DOCKET NO. 2010-01

RE: GROTON WIND, LLC

**EXHIBIT CONTAINING POST-CERTIFICATE CORRESPONDENCE
BETWEEN GROTON WIND, LLC AND
NEW HAMPSHIRE DEPARTMENT OF ENVIRONMENTAL SERVICES**

Re: Groton Wind Farm, Revised Site Plans
SEC Docket No. 2010-01
Wetlands File No. 2010-00745
Alteration of Terrain Permit No. 100325-033

VHB Vanasse Hangen Brustlin, Inc.
Project Revisions
Sheet 1 of 2
Groton Wind, LLC
Groton Hollow Road
Groton, NH

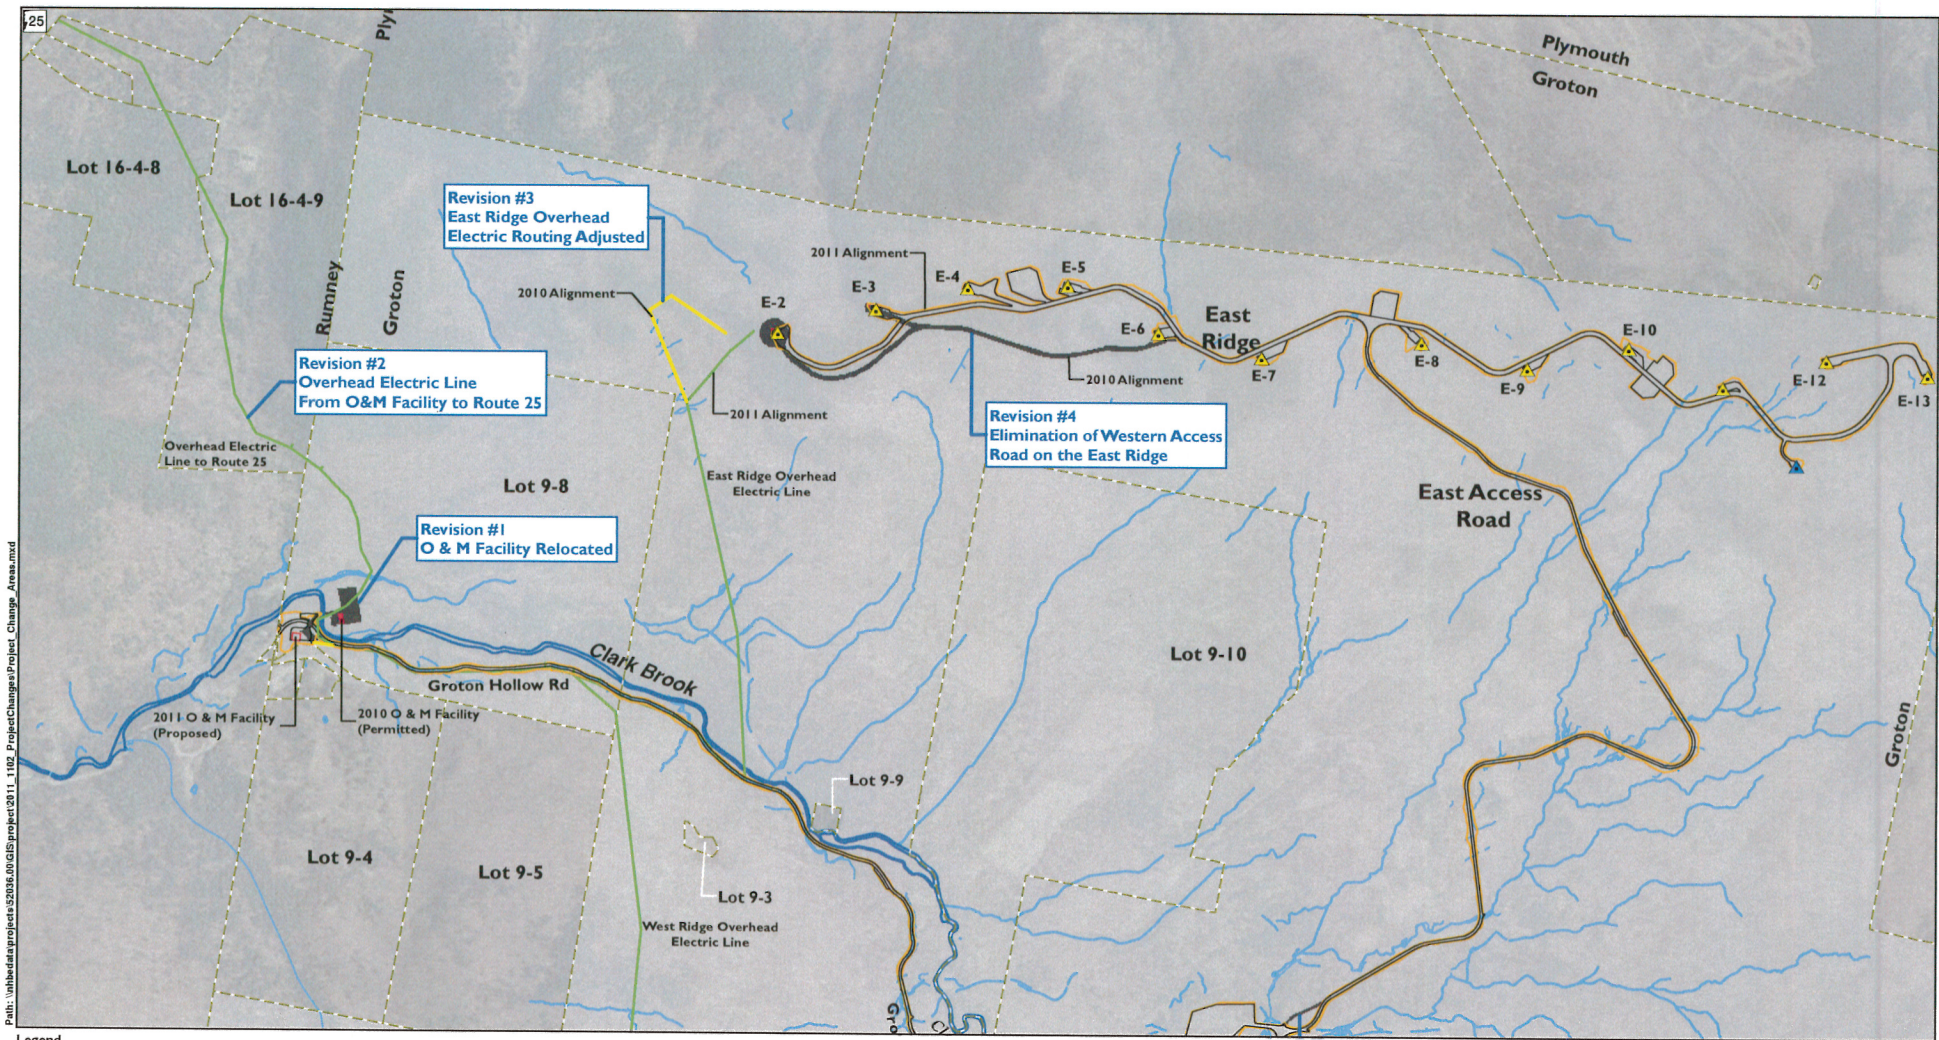
Note:
The intent of this figure is to show changes from the July 9, 2010 Site Plan to October 28, 2011 Site Plans for the Groton Wind Farm.

Project Revisions
Sheet 2 of 2

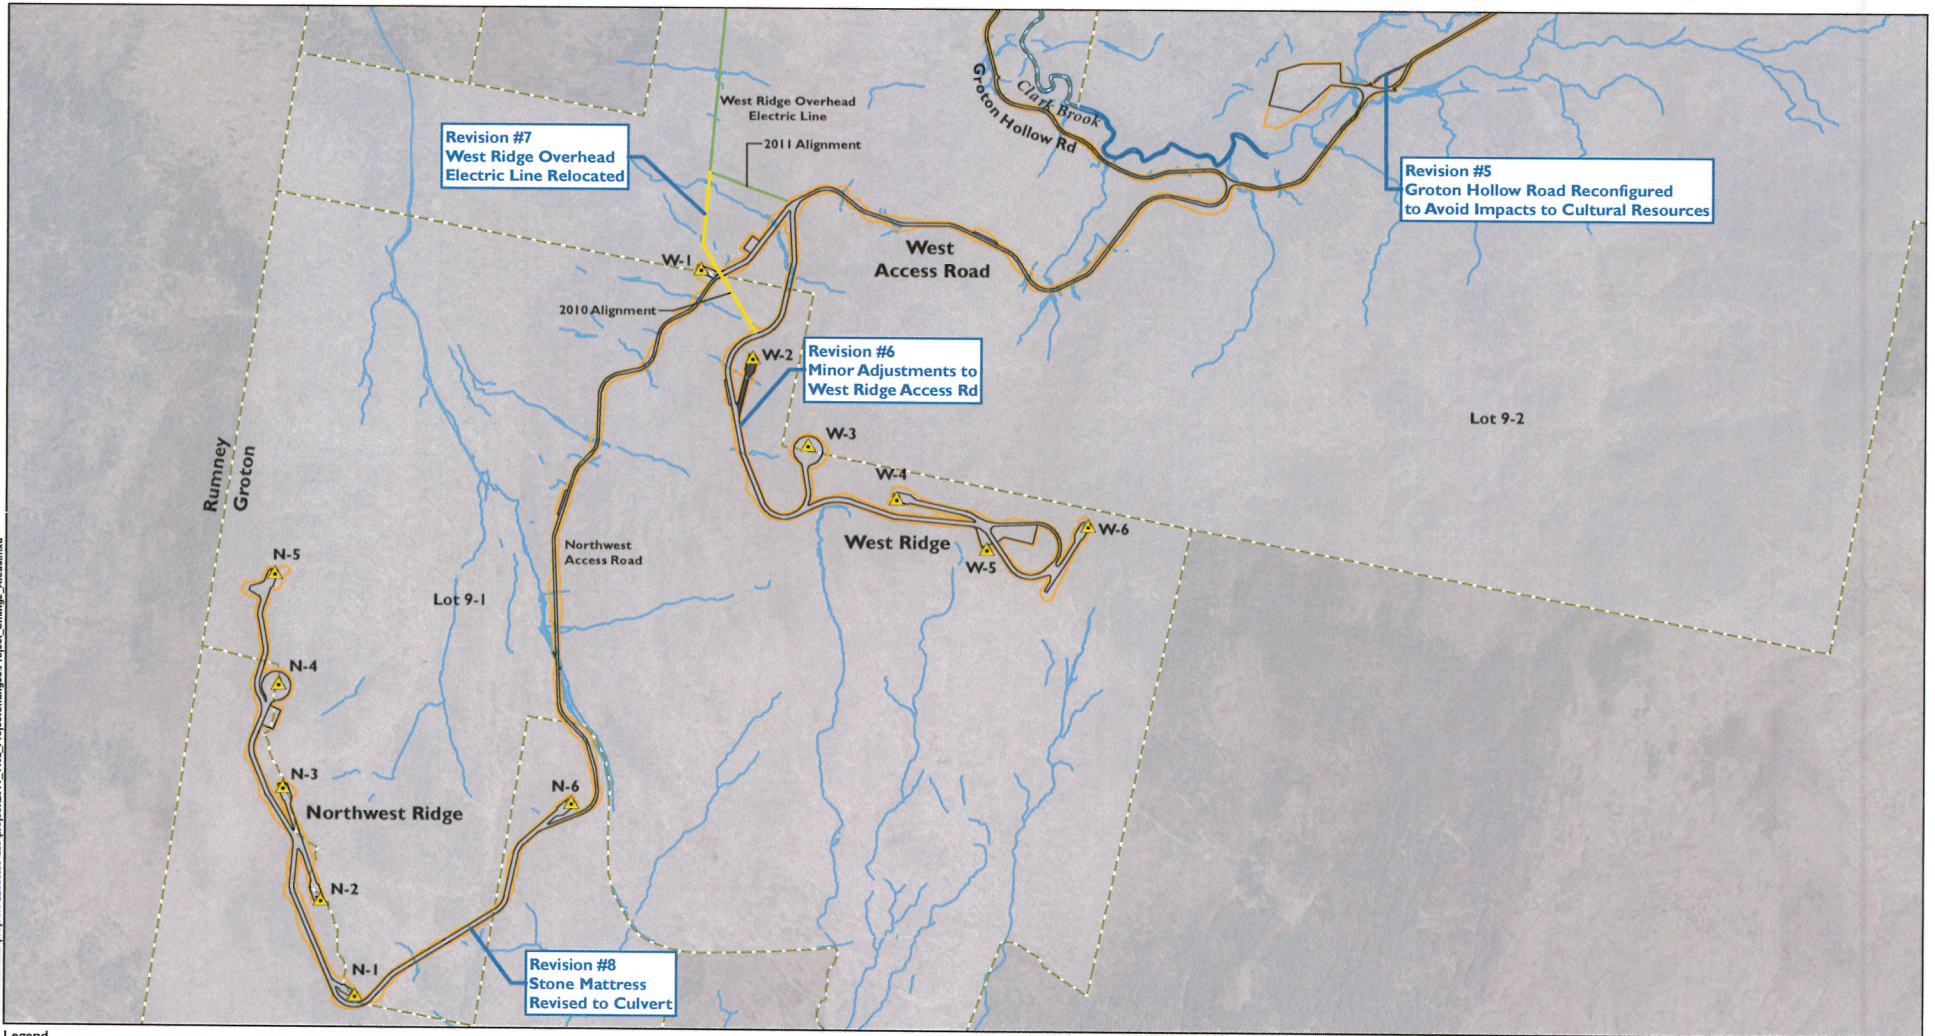
Note:
The intent of this figure is to show changes from the July 9, 2010 Site Plan to October 28, 2011 Site Plans for the Groton Wind Farm.
